Linac4 Beam Coordination Committee - Meeting 22 held on 9 December 2010

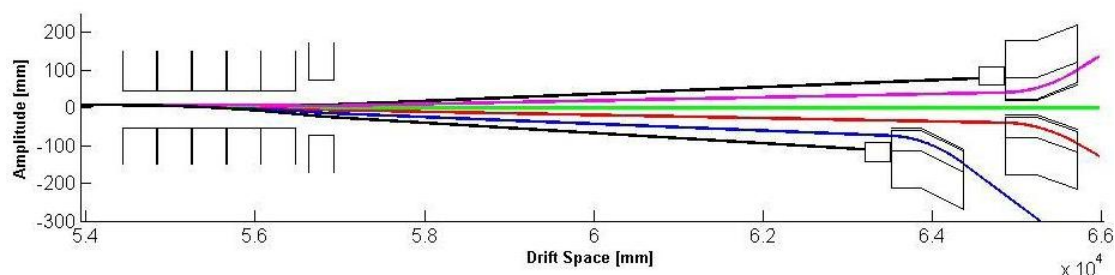
The perturbation generated by the injection chicane magnets (additional focusing) have to be compensated. Two possible compensation strategies were investigated:

The active compensation: Time varying quadrupolar fields in periods 3 and 14.

The passive compensation: Adding pole face rotation to the BS magnets.

Simulations indicate that both active and passive compensation give acceptable results. Additional power converters are required for the active compensation.

After discussion, the decision for going officially for the active compensation solution was approved by all the participants.
